Access Compliance Report

Public Rights-of-Way

(Curb Ramps)

Intersection ID: N/A	Main Street: SHOPTON_RD	Cross Street: DIXIE_RIVER_RD	Location: S
ADA ID: D690721174B0	Ramp Type: PerpDiag	Initial Pass/Fail: Fail	Overall Compliance: No
Severity Score: 22.5			
Codes/Mitigation Info/Possible Solution		Field Measurements/Component Compliance

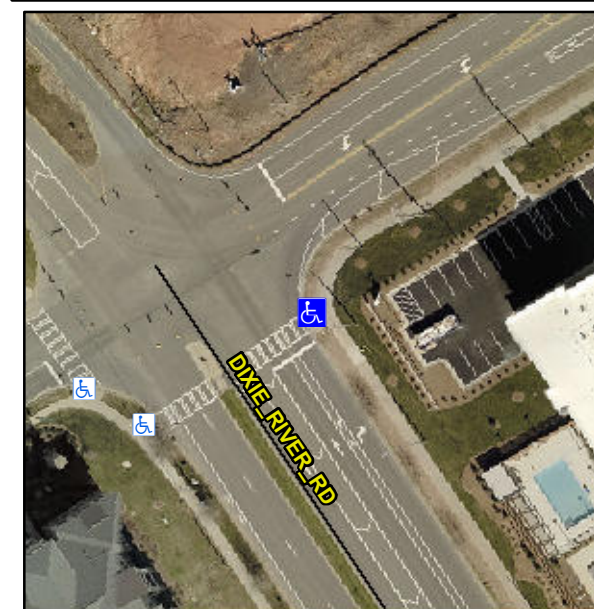
PROW/ADA:

R304.5.1, R304.2.2, R304.5.3

Compliance	Description	Data	Compliance	Description	Data
N/A	Ramp Length (in)	96.0	No	Ramp Slope (%)	9.1
No	Ramp Width (in)	46.5	No	Ramp XSlope (%)	4.8
N/A	Flare Type LT	N/A	N/A	Flare Type RT	N/A
N/A	Flare Slope LT (%)	N/A	N/A	Flare Slope RT (%)	N/A
N/A	Flare Traversable LT?	N/A	N/A	Flare Traversable RT?	N/A
N/A	Landing Length (in)	N/A	N/A	DWS Provided?	N/A
N/A	Landing Width (in)	N/A	N/A	DWS Contrast?	N/A
N/A	Landing Slope (%)	N/A	N/A	DWS Length (in)	N/A
N/A	Landing X Slope (%)	N/A	N/A	DWS Full Width?	N/A
N/A	Landing Curb? (Y/N)	N/A	N/A	DWS Offset (in)	N/A
N/A	Shared Landing?	N/A			
N/A	Gutter Ponding?	N/A	N/A	Gutter Slope (%)	N/A
N/A	Gutter Lip Ht (in)	N/A	N/A	Gutter X Slope (%)	N/A
N/A	Painted X Walk1?	No	N/A	Painted X Walk2?	Yes
	X Walk 1 Direction	To N		X Walk 2 Direction	To W
N/A	X Walk 1 Width (in)	N/A	N/A	X Walk 2 Width (in)	112.0
	X Walk 1 Slope (%)	4.4		X Walk 2 Slope (%)	1.2
	X Walk 1 X Slope (%)	1.4		X Walk 2 X Slope (%)	3.1

N/A	Ramp inside XWalk1?	N/A	N/A	Ramp inside XWalk2?	Yes
	Road Slope (%)	2.4	N/A	Clear Space?	N/A
	Road X Slope (%)	0.7	N/A	Clear Space to XWalk (in)	N/A
N/A	Any Obstructions?	N/A	N/A	Storm Grate/Utility Hazard?	N/A
	Obstruction Type			Storm Grate/Utility Type	
		N/A			N/A
		Yes		Surface Condition? (G/P)	Good

Possible Solutions:

Remove & Replace Curb Ramp With Two New Directional Ramps or Equivalent.
